Report Date: June 4, 2025 Case #25-229

Location: 200 Laurel Lake Drive

Major Site Plan to construct 7 duplex villa buildings

Hudson Planning Commission	SITE PLAN REVIEW – LAUREL LAKE VILLAS
Case No. 25-229	June 9, 2025

Fig. 1 - June 9, 2025 PC Submittal

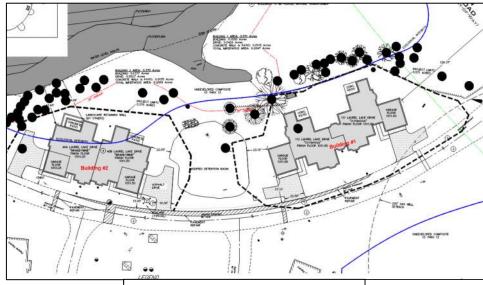
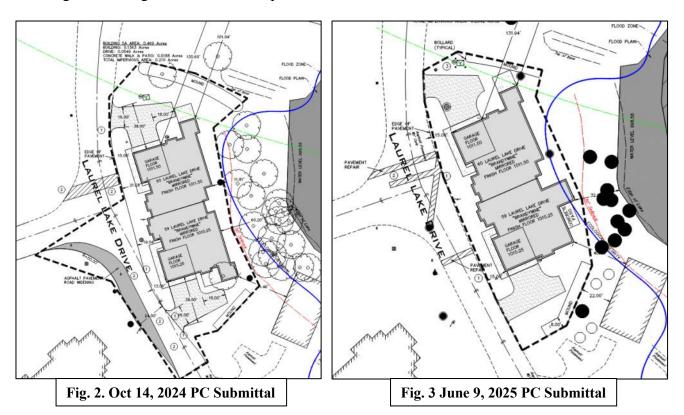
Staff notes the site plan request for these three buildings is not a resubmit of the previous request as following design changes have been proposed in response to the October 14, 2024 Planning Commission discussion:

1. Buildings #1 and #2 have been repositioned. Building #2 has been redesigned to a duplex with side loaded garages and is located further from the access drive. The proposed stormwater pond has been reconfigured.

2. The applicant is no longer requesting to realign the access drive. The building has been slightly redesigned allowing the existing drive to remain in place.

Fig. 5

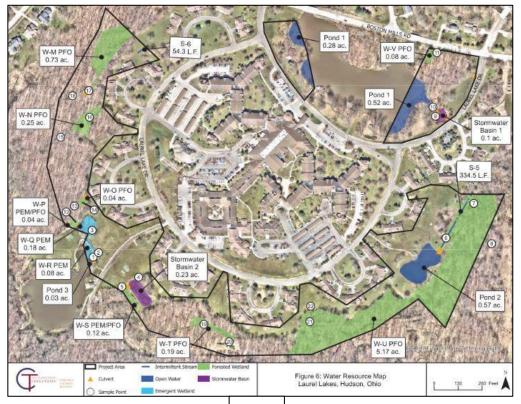
<u>Updates to Application</u>: The applicant has submitted a letter with the current Planning Commission submittal. The letter was written by Carrie Ricker, Project manager and profession wetland specialist, of Verdantas (formerly CT Consultants), the environmental science and engineering firm that has completed the environmental documentation for the site. The letter states: *Verdantas, LLC* (formerly CT Consultants, Inc.) prepared the Wetland Delineation Report for the Laurel Lake, Hudson, Ohio property in August 2022. We have been requested to provide clarification around Pond-1 jurisdiction and the type of surface water feature this is considered. Pond-1 as labeled on the attached Water Resource Map for Laurel Lake (see Figure 5)., is considered a tributary impoundment under (a)(3) of the Waters of the United States (WOTUS) Regulatory Ruling. Pond-1does not contain wetland vegetation and is not considered a wetland by definition. This feature is an open water impoundment that extends upstream as a part of Lake Forest on the north side of Boston Mills Road. This feature is an impoundment of an unnamed tributary to
